HISTORIC AND DESIGN REVIEW COMMISSION

HDRC CASE NO: 2019-247
ADDRESS: 909 N HACKBERRY ST
LEGAL DESCRIPTION: NCB 529 BLK 2 LOT N 92.5 FT OF 13 & 14
ZONING: IDZ, H
CITY COUNCIL DIST.: 2
DISTRICT: Dignowity Hill Historic District
APPLICANT: Haley Serna/Open Studio Architecture
OWNER: Michael & Teresa Garansuay
TYPE OF WORK: Construction of 2, two-story, residential structures, and two rear residential structures
APPLICATION RECEIVED: April 29, 2019
60-DAY REVIEW: June 28, 2019
CASE MANAGER: Edward Hall
REQUEST:

Dignowity Residences

project #: 19.010
 date: 4.29.19
 drawn by/checked by: HS/GS
 drawing title: SITE PLAN 1" = 20'-0"
 drawing number: AS100

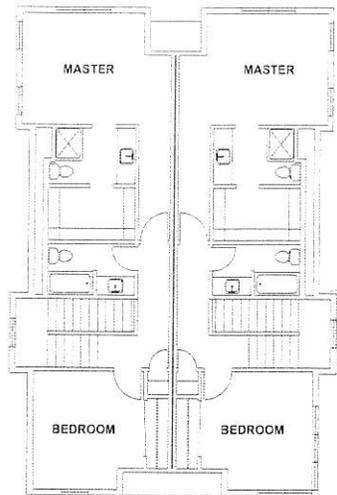
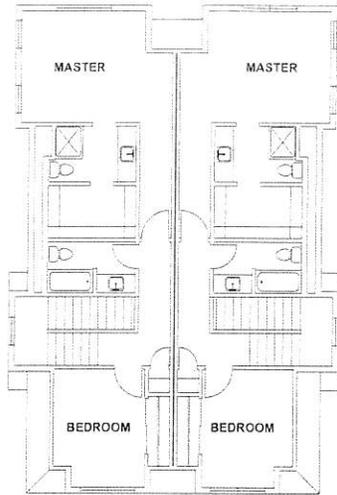
- c. **LOT COVERAGE** – Per the Guidelines, the building footprint for new construction should be no more than fifty (50) percent of the size of the total lot area. The applicant has proposed footprints for four structures which is atypical of the historic development pattern within the district. The applicant is responsible for complying with the Guidelines and ensuring that the proposed lot coverage does not exceed fifty (50) percent.

- d. **VEHICULAR ACCESS** – The applicant has proposed vehicular access into the site from Fayn Way. The Guidelines for Site Elements 5.B.i. notes that a similar driveway configuration to those that are found historically within the district should be used for new driveways. Typically, driveways are ten (10) feet wide within the Dignowity Hill Historic District. The proposed driveway width is inconsistent with the Guidelines.

- e. **SITE PAVING** – The applicant has proposed an amount of site paving that per the submitted site plan, appears inconsistent with the amount of site paving that is found historically within the Dignowity Hill Historic District.

- 1b. **SETBACKS & ORIENTATION** – According to the Guidelines for New Construction, the front facades of new buildings are to align with front facades of adjacent buildings where a consistent setback has been established along the street frontage. Additionally, the orientation of new construction should be consistent with the historic examples found on the block. While the applicant has oriented both structures to N Hackberry, the applicant has not provided setback measurements. Staff finds that the applicant should provide a site plan or a setback diagram which notes the proposed setback is appropriate and consistent with the Guidelines.

- 1c. **SETBACKS (Fayn Way)** – The applicant has not noted a side setback on Fayn Way. On this block, Fayn Way connects N Hackberry to N Mesquite. There are no primary historic structures that feature a front orientation toward Fayn Way. On other block, such as across N Hackberry at N Hackberry and Fayn Way, historic structures feature a minimal side setback from the Fayn Way, approximately ten (10) feet.

- 1e. **BUILDING SPACING** – The applicant has proposed spacing between the two primary structures that is less than that which is found historically within the Dignowity Hill Historic District. Staff finds that additional building should be incorporated into the design.

- 2b. SETBACKS & ORIENTATION – The Guidelines for New Construction 5.B. notes that the predominant orientation of accessory structure should be matched. Additionally, the historic setback patterns found historically within the district should be used. Generally, accessory structures within the Dignowity Hill Historic District are located in the rear corners of lots. Accessory structures that span the entire length of the property line, as proposed, are generally inconsistent with the historic development pattern for accessory structures within the District and inconsistent with the Guidelines.

- 2c. SCALE & MASS – Per the Guidelines for New Construction 5.A.i. accessory structures should be designed to be visually subordinate to the principal historic structure in terms of their massing, height and form. While the proposed accessory structures may feature a height, width and massing that are subordinate to the proposed new construction requested in item one, staff finds the proposed massing to be inconsistent with the historic examples found in the immediate vicinity for accessory structures, which are all one story in height. Additionally, staff finds the proposed footprint of the rear accessory structures to be inconsistent with the Guidelines.

- i. That the applicant ensure that lot coverage does not exceed more than fifty (50) percent as noted in finding d.
- ii. That the applicant install a driveway and site paving that are consistent with the Guidelines and the historic examples found throughout the Dignowity Hill Historic District as noted in findings e and f.

- iii. That all mechanical equipment be screened from view from the public right of way as noted in finding g.
- iv. That the applicant submit a site plan or a setback diagram which notes the proposed setback is appropriate and consistent with the Guidelines as noted in finding 1b and 1c.

- vi. That the applicant provide a large separation between structures as noted in finding 1e.
- vii. That the applicant confirm that a foundation height that is consistent with the Guidelines in utilized as noted in finding 1f.

- xiii. That the applicant reduce the massing and height of the proposed rear structures and incorporate setbacks and orientations that are consistent with the Guidelines as noted in findings 2a through 2d.

- STANDING SEAM METAL ROOF
- PAINTED WOOD FASCIA
- WOOD OR ALUM-CLAD SINGLE HUNG WINDOWS
- HARDIE SIDING (PAINTED) W/MITORED CORNERS

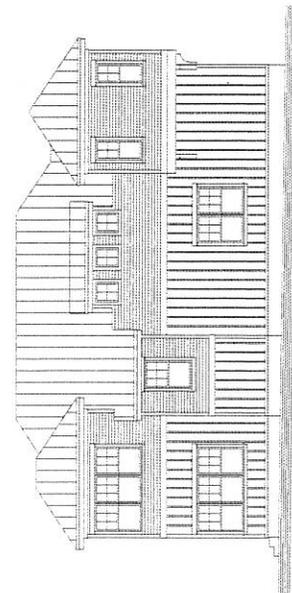
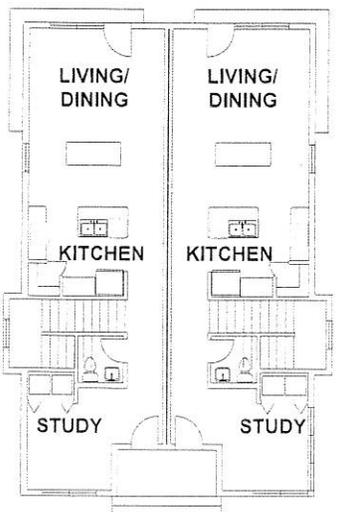
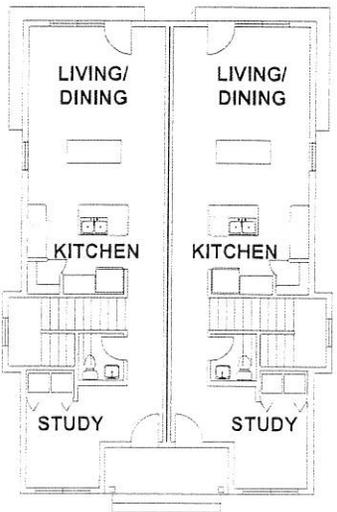
- 1d. **SCALE & MASS** – Per the Guidelines for New Construction 2.A.i., a height and massing similar to historic structures in the vicinity of the proposed new construction should be used. In residential districts, the height and scale of new construction should not exceed that of the majority of historic buildings by more than one-story. This block on N Hackberry features single story structures. There is an example of a two-story, historic structure in the immediate vicinity, which is located at the corner of N Hackberry and Hays. Staff finds the current scale and mass to be inappropriate when coupled with the proposed architectural elements. Staff finds that the inclusion of architectural elements that are in-kind with those found historically in the district, as well as those that relate to the massing of one story, historic structures found in the vicinity may result in a massing that is appropriate.

- 1f. **FOUNDATION & FLOOR HEIGHT** – According to the Guidelines for New Construction 2.A.iii., foundation and floor height should be aligned within one (1) foot of neighboring structure’s foundation and floor heights. Per the elevations submitted with the application documents, the applicant has proposed a foundation height of at least one (1) foot. Staff finds the proposed foundation heights to be appropriate; however, the applicant should confirm the exact height.

- 1g. **ROOF FORMS** – The applicant has proposed a number of roof forms that include primary hipped roofs, projecting gabled and hipped roof forms, and clipped gable forms. Generally, historic structures located within the Dignowity Hill Historic District feature simplified roof forms. Staff finds the proposed roof forms to feature profiles and forms that are not found historically within the district. Staff finds that the applicant should simplify the proposed roof forms.

- 1h. **WINDOW & DOOR OPENINGS** – The applicant has proposed window and door openings that are generally sized consistently with those found historically within the Dignowity Hill Historic District. Staff finds that all grouped windows should be separated by a mullion of at least six (6) inches in width. Additionally, staff finds that additional fenestration should be added on portions of the façade that are blank, primarily kitchen and dining rooms on the first floor.

- 1i. **MATERIALS** – The applicant has proposed materials that include horizontal Hardie siding, vertical Hardie board and batten siding, wood or aluminum clad wood windows, wood trim and standing seam metal roofs. Generally, staff finds the proposed materials to be appropriate; however, composite, horizontal siding should feature an exposed profile of four inches and a thickness of approximately $\frac{3}{4}$ ". A composite siding should feature smooth finishes and mitered corners. Window and door trim should feature thicknesses that are appropriate for the thickness of the siding; at least 1 inch, and should be installed abutting the siding. Board and batten siding should feature a thickness of approximately $\frac{3}{4}$ ", boards that are 12 inches wide and seams that are $1 - \frac{1}{2}$ " in width. The proposed standing seam metal roof should feature panels that are 18 to 21 inches wide, seams that are 1 to 2 inches in height, a crimped ridge seam and a standard galvalume finish. A low profile ridge cap may be submitted to staff for review. An industrial ridge cap is not to be used.

- 1j. **WINDOW MATERIALS** – The applicant has proposed either wood, or aluminum clad wood windows featuring a one over one profile. Staff finds the proposed windows to be appropriate; however, meeting rails must be no taller than 1.25" and stiles no wider than 2.25". White manufacturer’s color is not allowed, and color selection must be presented to staff. There should be a minimum of two inches in depth between the front face of the window trim and the front face of the top window sash. This must be accomplished by recessing the window sufficiently within

- 1k. ARCHITECTURAL DETAILS – As noted in finding 1d, the applicant has proposed architectural details that are not found historically in the Dignowity Hill Historic District, including complex roof forms, recessed entrances and a lack of front porches. Staff finds that architectural elements that are found historically on structures on corner lots should be implemented, includes side entrance elements or a wraparound porch element. Additionally, staff finds that a formal porch element that includes porch massing comparable with those found historically in the district should be included.

- v. That the applicant either reduce the proposed massing, or propose architectural elements and roof forms that are more consistent with those found historically within the district as noted in finding 1d. As proposed, the massing is not appropriate for this lot.

- viii. That the applicant simply the proposed roof forms as noted in finding 1g.
- ix. That all grouped windows be separated by a mullion of at least six (6) inches in width. Additionally, additional fenestration should be added on portions of the façade that are blank, primarily kitchen and dining rooms on the first floor, as noted in finding 1h.

- x. That horizontal siding feature an exposed profile of four inches and a thickness of approximately $\frac{3}{4}$ ". A composite siding should feature smooth finishes and mitered corners. Window and door trim should feature thicknesses that are appropriate for the thickness of the siding; at least 1 inch, and should be installed abutting the siding. Board and batten siding should feature a thickness of approximately $\frac{3}{4}$ ", boards that are 12 inches wide and seams that are $1 - \frac{1}{2}$ " in width. The proposed standing seam metal roof should feature panels that are 18 to 21 inches wide, seams that are 1 to 2 inches in height, a crimped ridge seam and a standard galvalume finish. A low profile ridge cap may be submitted to staff for review. An industrial ridge cap is not to be used.

- xi. That the proposed wood or aluminum clad wood windows feature meeting rails must be no taller than 1.25" and stiles no wider than 2.25". White manufacturer's color is not allowed, and color selection must be presented to staff. There should be a minimum of two inches in depth between the front face of the window trim and the front face of the top window sash. This must be accomplished by recessing the window sufficiently within the opening or with the installation of additional window trim to add thickness. Window trim must feature traditional dimensions and architecturally appropriate sill detail. Window track components must be painted to match the window trim or concealed by a wood window screen set within the opening.

- xii. That the applicant incorporate traditional architectural elements, such as front porch massing, simplified roof forms and elements to address the corner of N Hackberry and Fayn Way, such as a wraparound porch as noted in finding 1k.
